DEVELOPMENT REVIEW BOARD--SPEED MEMO

DRB CASE NO/PROJECT NO: 1004258

Development Review Board 6/22/05 Agenda Item #29
Sketch Plat: Lots 27 & 28, Monterey Hills Addition Unit 2

RE: Monterey Hills Addition, Lots 27 & 28/sketch plat

PROPOSAL: MOVE MIDDLE LOT BOUNDARY WEST 9 FEET

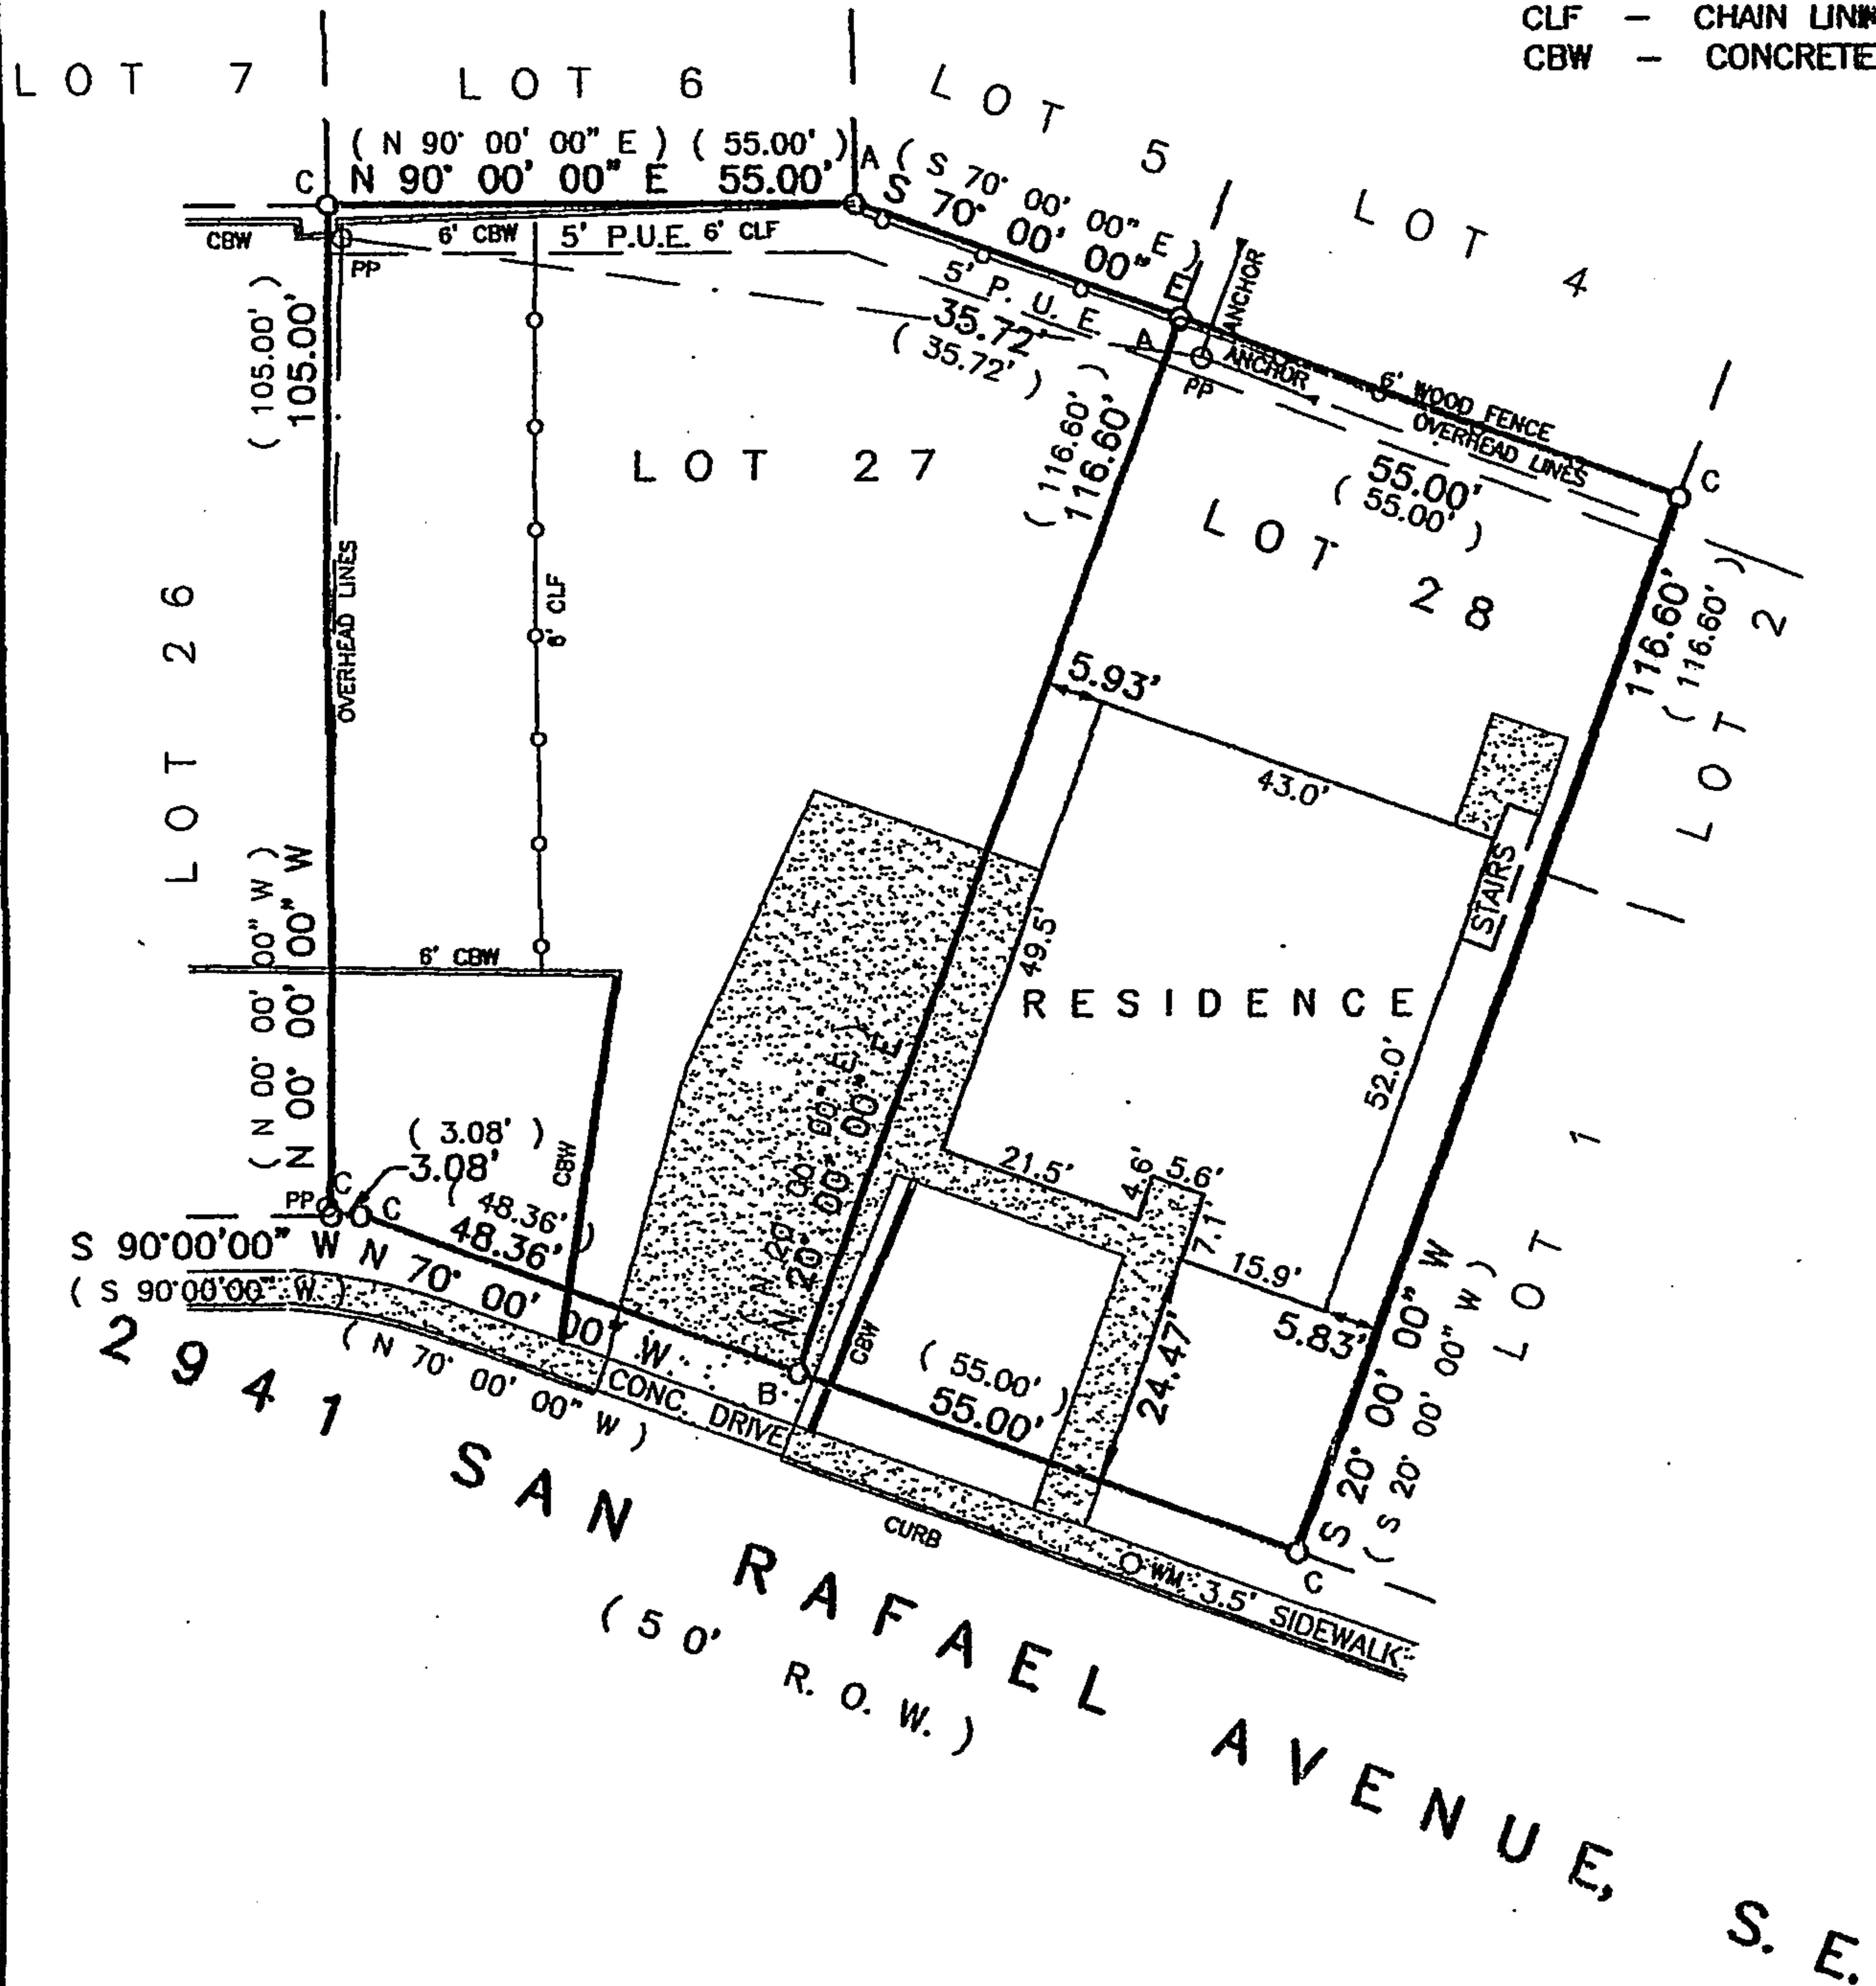
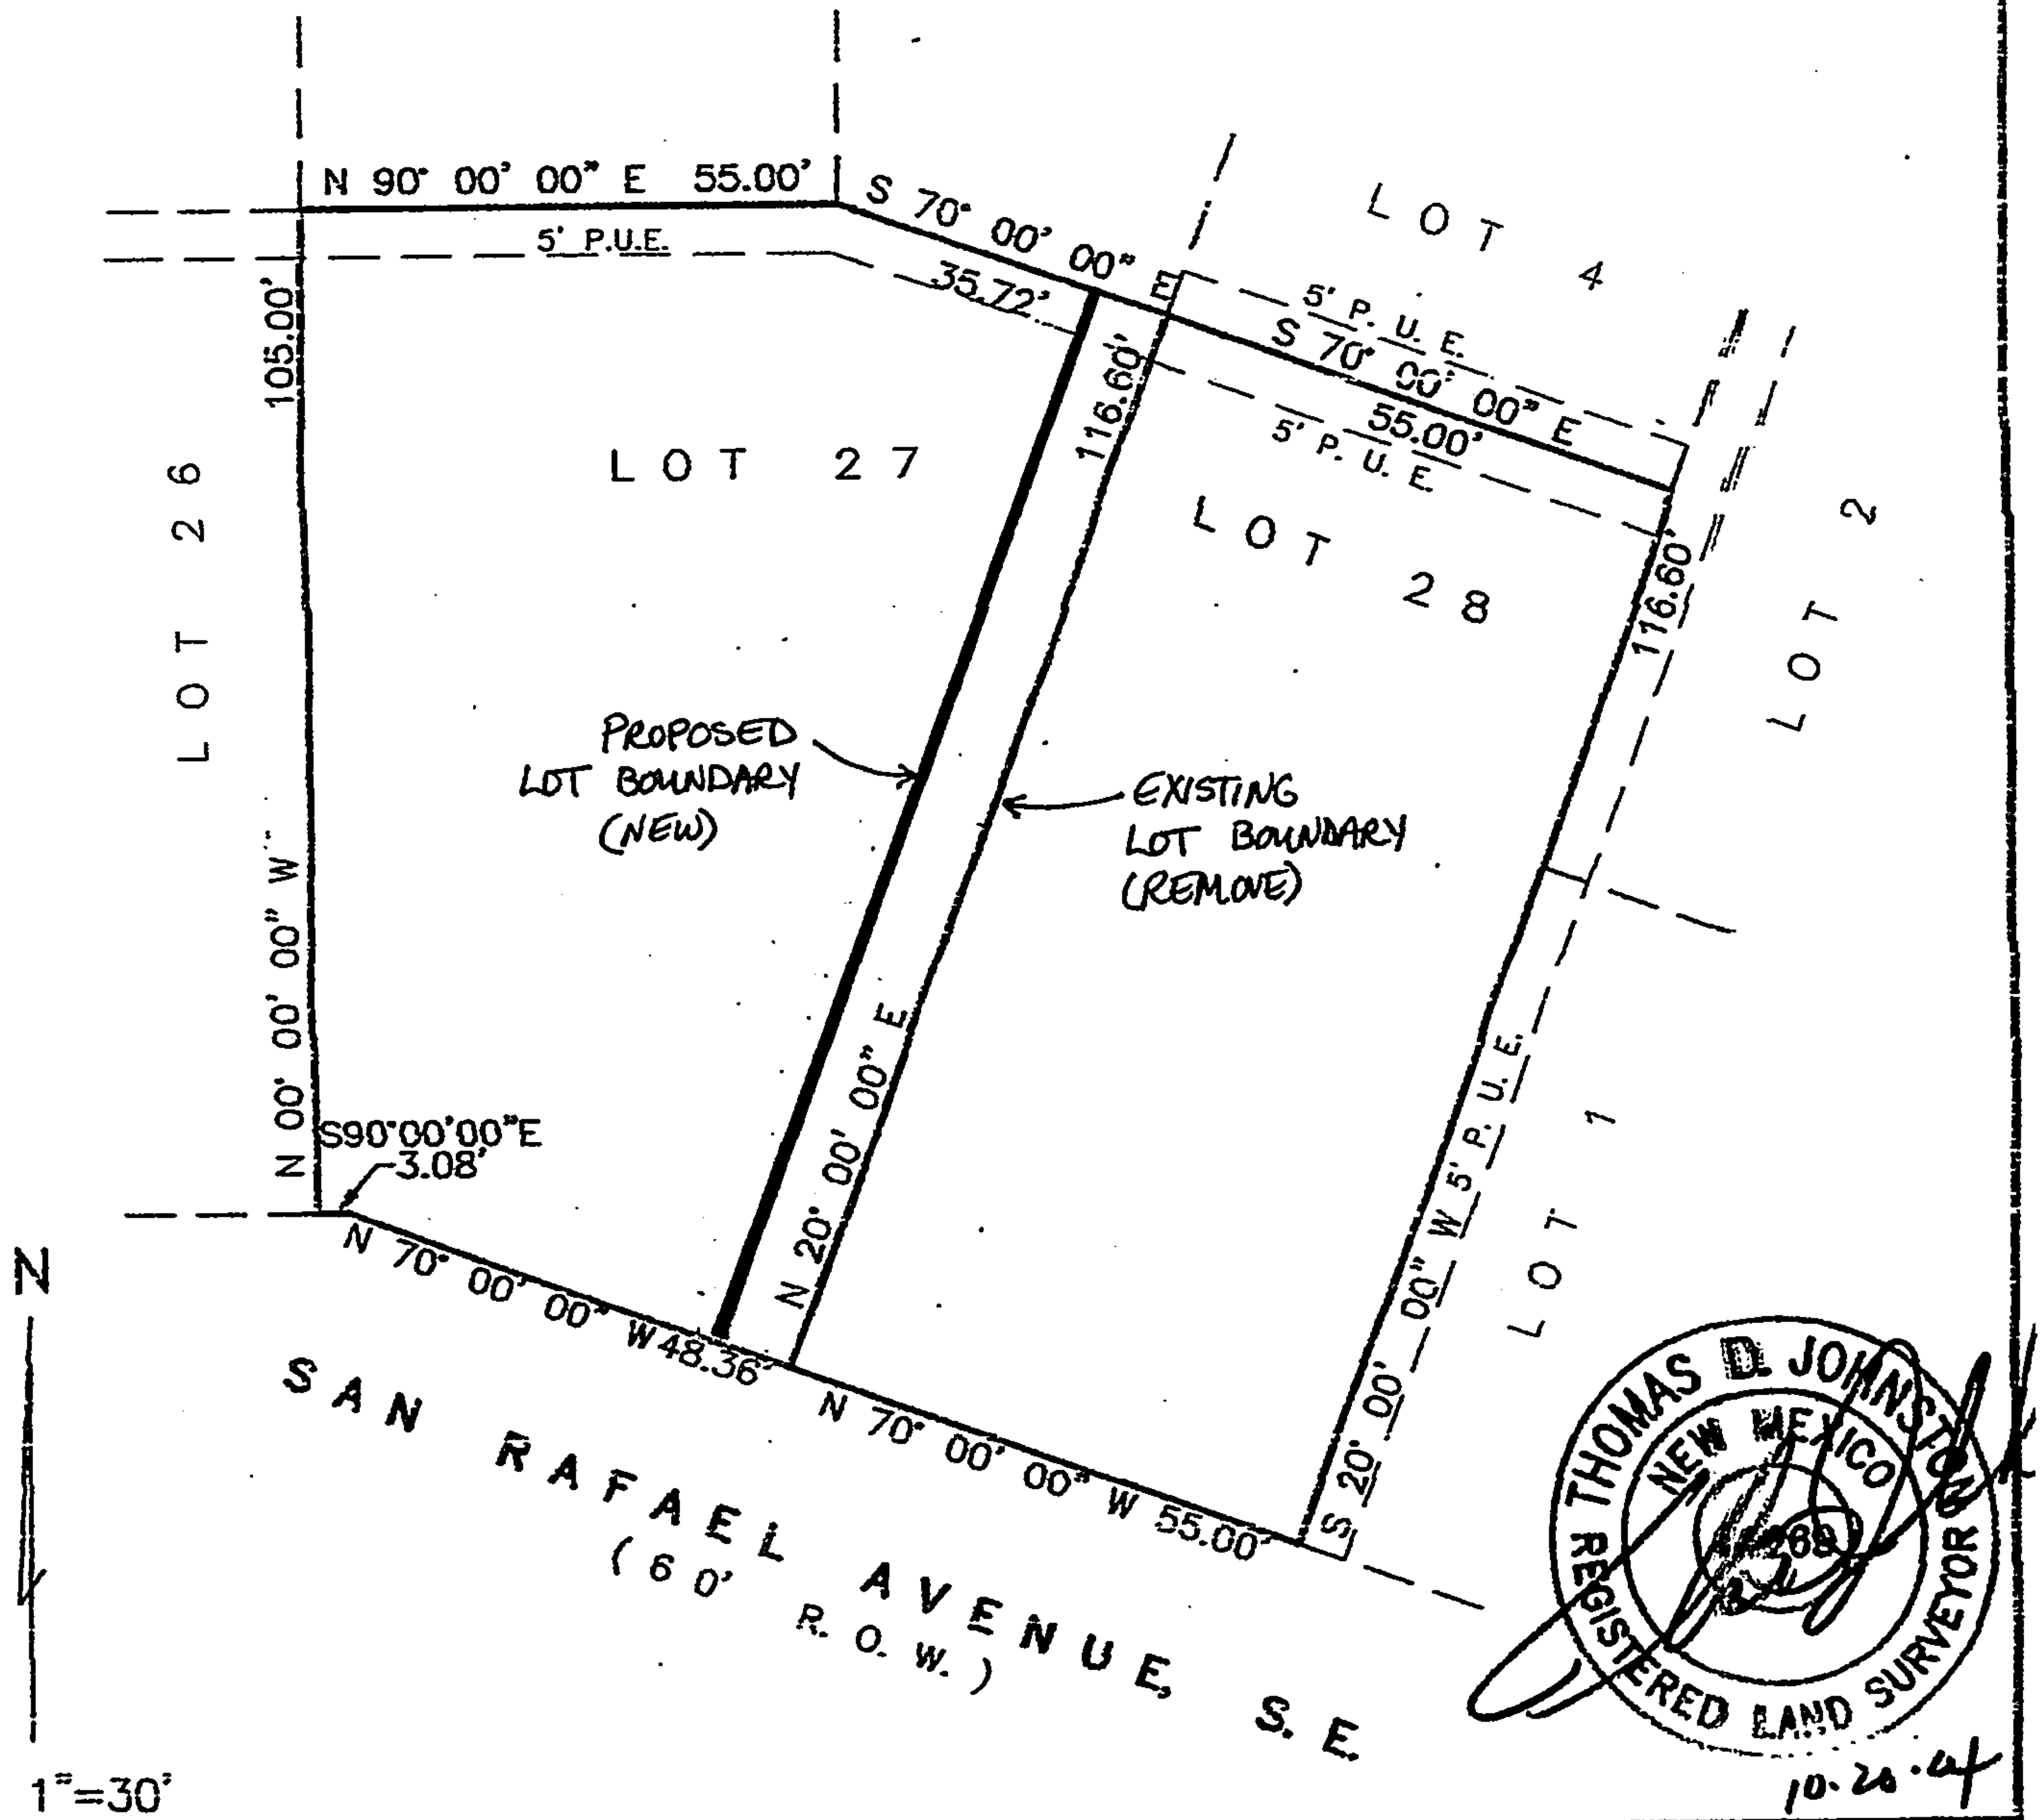
No adverse comments.

The applicant may want to consider a driveway ("Access") Easement on Lot 27 for the benefit of, and maintenance by, Lot 28. This would not require a platting action, and there would be no requirement for Impact Fees prior to July 1, 2007 (\$1,332 thereafter).

No objection to this request. Minimum lot sizes are met.

AGIS DXF approval is required for replats.
